Ordinary Meeting of Council

ITEM 9.1 DEVELOPMENT APPLICATION - DA.2023.0160 - 10-24
SALTBUSH PARADE TRALEE - CONSTRUCTION OF 8
TWO STOREY DWELLINGS

ATTACHMENT 1 DA.2023.0160 - S4.15 MATTERS FOR CONSIDERATION -
ASSESSMENT REPORT - 10-24 SALTBUSH PARADE
TRALEE

DELEGATED REPORT - DA.2023.0160

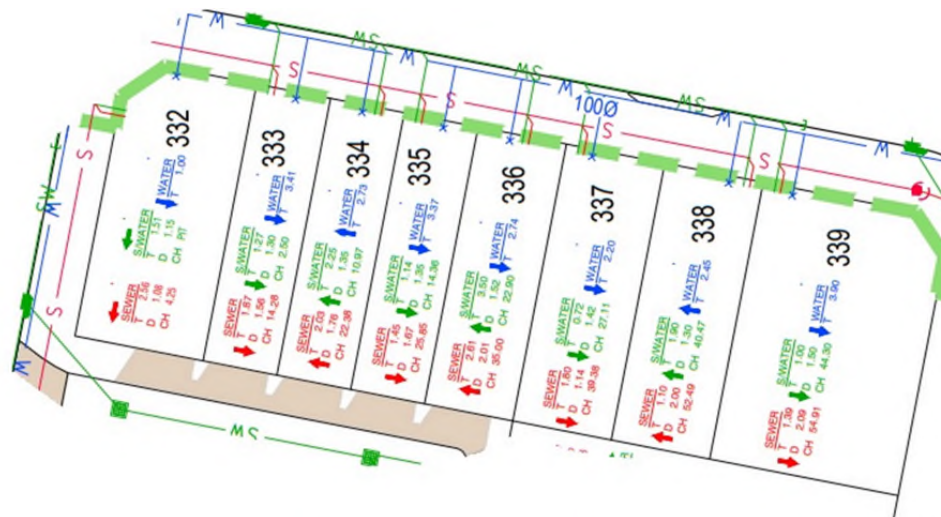
The lots are serviced with council water services along Saltbush Parade front and were clearly marked and present at the time of site inspection. Please refer WAE plan for more detail and exact location (Figure 1).

As per the WAE plan Sewer tie is provided to the lots 333-339 from Saltbush Parade and Lot 332 from Storksbill Terrace. The ties were clearly marked and present at the time of site inspection.

The proposed development does not affect council sewer and stormwater easement. Please refer to WAE Plan (Figure 1) for more detail and exact locations.

Figure 8: Comparison of proposed (left), compliance with zero lot line (centre) and compliance with PPOS (right)

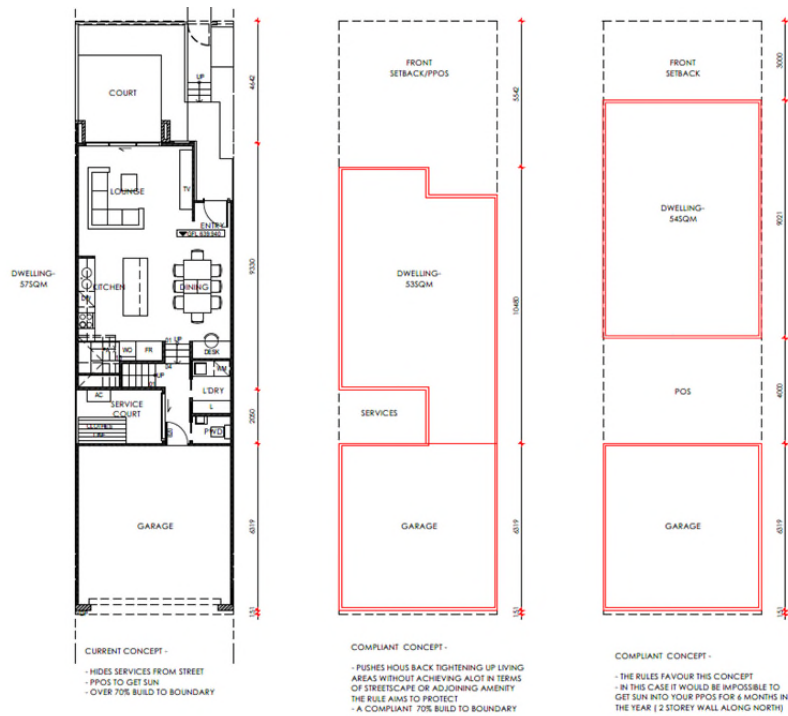
Lot 332-338 range in area between 134.9 – 229.6 sqm. Consistent along all lots is the 22.49m length. With a garage of 6.3m, front setback of 4m leaves a 12m functional living area. Review of the plan allows for functional (and not excessively large) kitchen, dining, lounge, stairs,

The 22.49m length is less than many small lots within the estate, making 15.74m zero lot line control difficult to achieve without severely impacting the dwelling functionality.

The applicant submitted an illustrative design concept which indicates the potential building footprint if it were to comply with the relevant controls and as can be seen from Figure 8, the compliance with the relevant controls severely restricts the amount of usable living space and could potentially end up creating a non-harmonious streetscape character.

Despite non-compliance with the zero lot line controls under Table 1 of Part 7 of SJDCP 2015, the variation to the control is unlikely to result in any adverse impacts on privacy, amenities and overshadowing on adjoining lots. Considering that the development meets the relevant objectives as discussed above, the variation to the zero lot line control is found to have a planning as well as an environmental merit. Therefore, the variations to zero lot control, in this instance is supported.
